MIRAMAR HEIGHTS SUBDIVISION,
RESUBDIVISION OF LOT 4, BLOCK2, &
NORTH HALF OF LOT 3, BLOCK 2

APPLICATION NUMBER 3 DATE October 20, 2011

DETAIL SITE PLAN

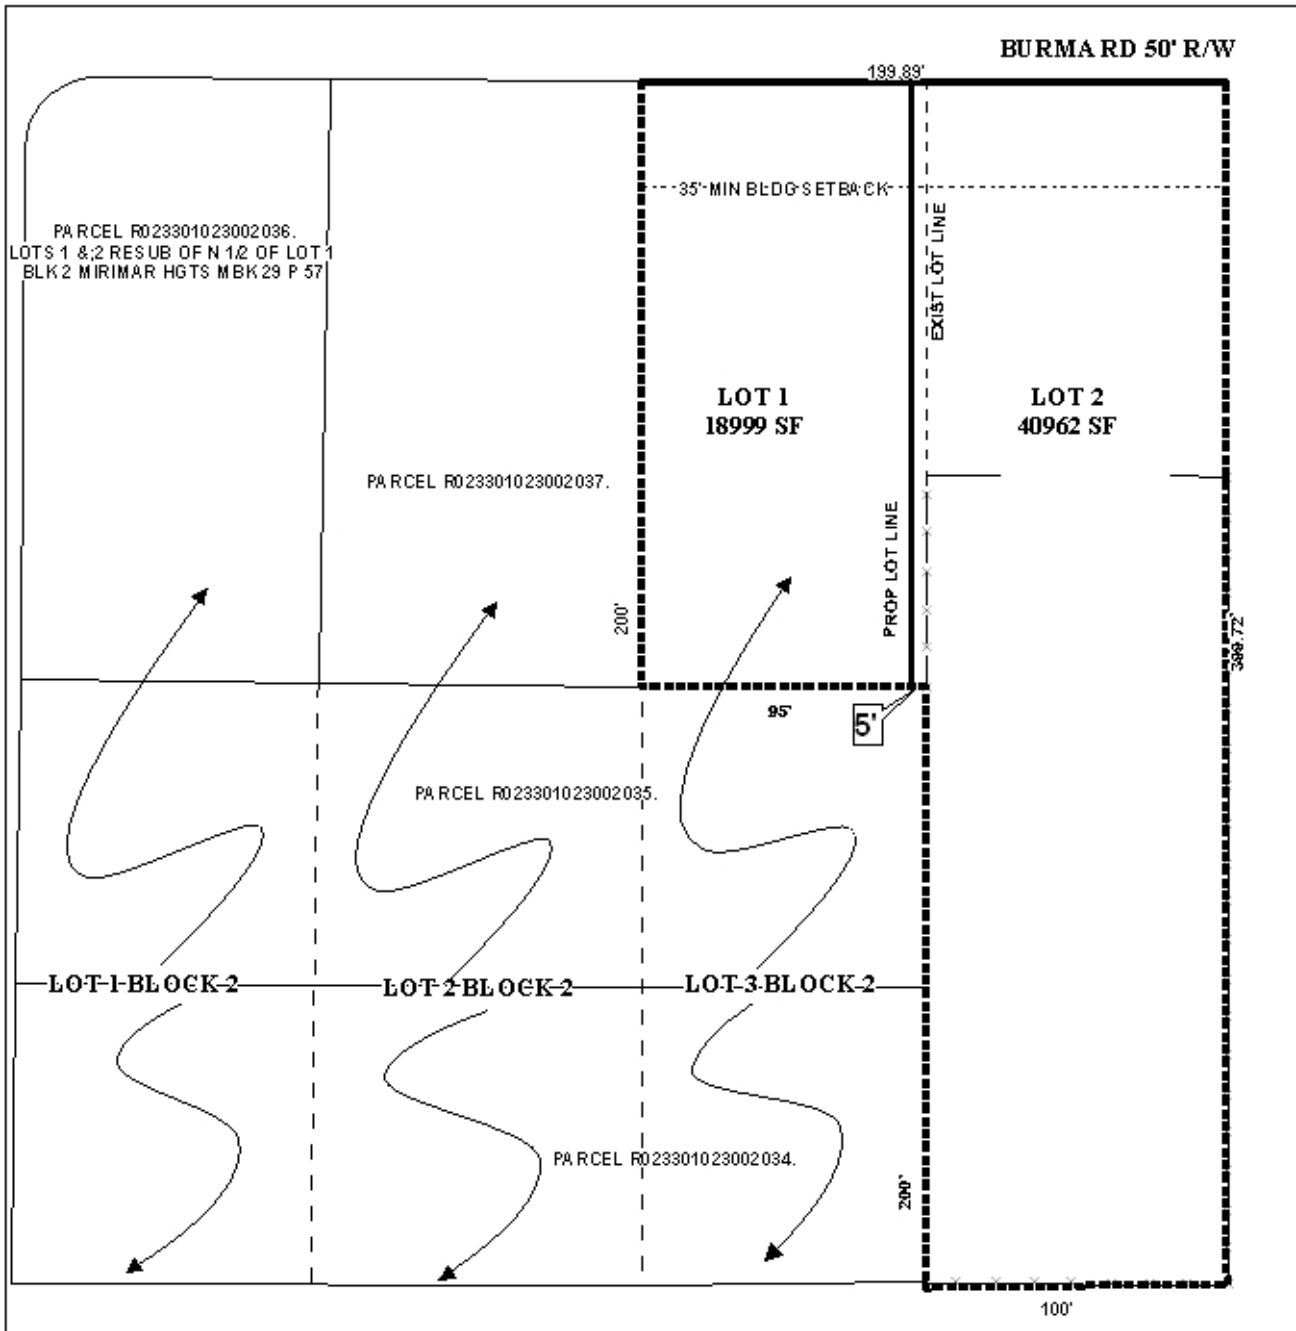
The preliminary plat should illustrate by means of building survey that no setback violation occurs by the shifting of the lot line.

The lot sizes are labeled on the preliminary plat, and both lots exceed the minimum size required by Section V.D.2. of the Subdivision Regulations of 7,200 square feet. The proposed Lot 2 exceeds the maximum length to depth ratio of 3.5; therefore, a waiver of Section V.D.3., would be required.

The 35-foot minimum building setback line exceeds the required 25-foot minimum building setback line in Section V.D.9. of the Subdivision Regulations, is shown for the subdivision, and should be retained on the Final Plat if approved. It should be noted, if any existing structures on either proposed lots are within the minimum setbacks, future additions to the residences would not be allowed in the setback without a successful variance application to the Board of Zoning Adjustment.

It should be noted that there should be no change in the number of curb cuts to each lot; therefore, the placement of a note on the Final Plat stating one curb cut to each lot is allowed with the size, design and location approved by Traffic Engineering and conforms to AASHTO standards.

- 1) submission of a revised preliminary plat illustrating the buildings on each lot;
- 2) inclusion of the remaining portion of Lot 3, Block 2 Miramar Heights;

- 3) retention of the minimum 25-foot minimum building setback line from Burma Road, as required by Section V.D.9. of the Subdivision Regulations;
- 4) the labeling of each lot with its size in square feet, or placement of a table on the plat with the same information;

- 1) *failure to provide a revised preliminary plat illustrating the inclusion of the remaining portion of Lot 3, Block 2 Miramar Heights.*
